IN THE DRAWING

Inventor: MITSURU MAEDA ET AL.
Appln. No.: 09/816,119 GAU: 2625
Filed: March 26, 2001
Confirmation No.:
SHEET 3 of 8

Reply to Office Action
Dated 3/29/04
Replacement Sheet

FIG. 9

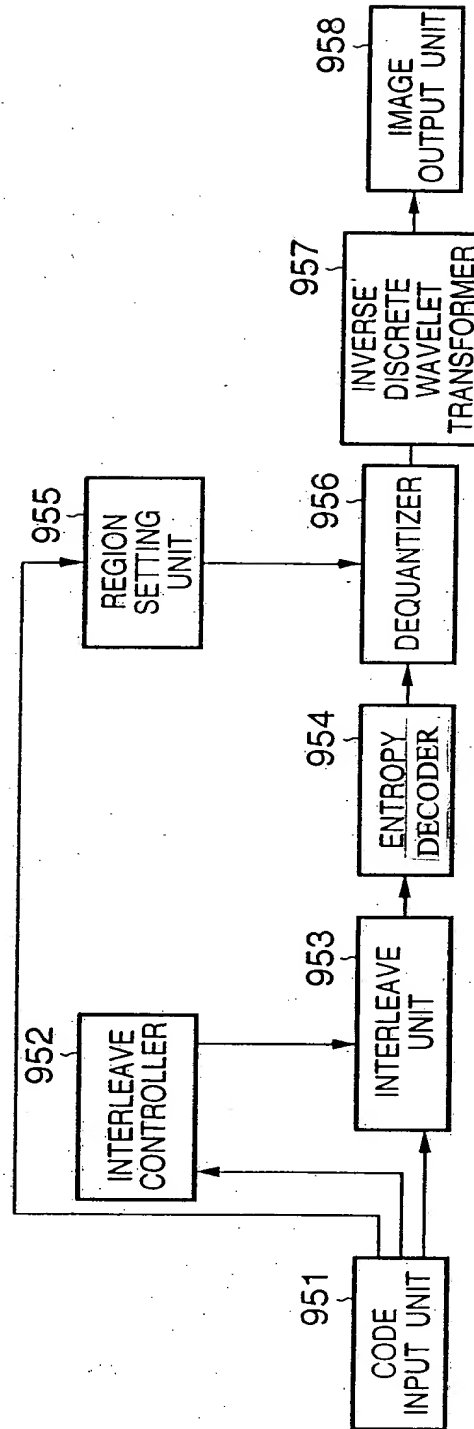
The attached sheets of drawings include changes to Figs. 9 and 12-18C. In particular, block 954 of Fig. 9 has been changed from “ENTROPY DECORDER” to --ENTROPY DECODER--. Furthermore, block 1004 of Fig. 12 has been changed from “ENTROPY ENCORDER” to --ENTROPY ENCODER--. Moreover, Figs. 12-18C have been labeled as --PRIOR ART--. The attached sheets of drawings replace the original sheets including Figs. 9 and 12-18C.
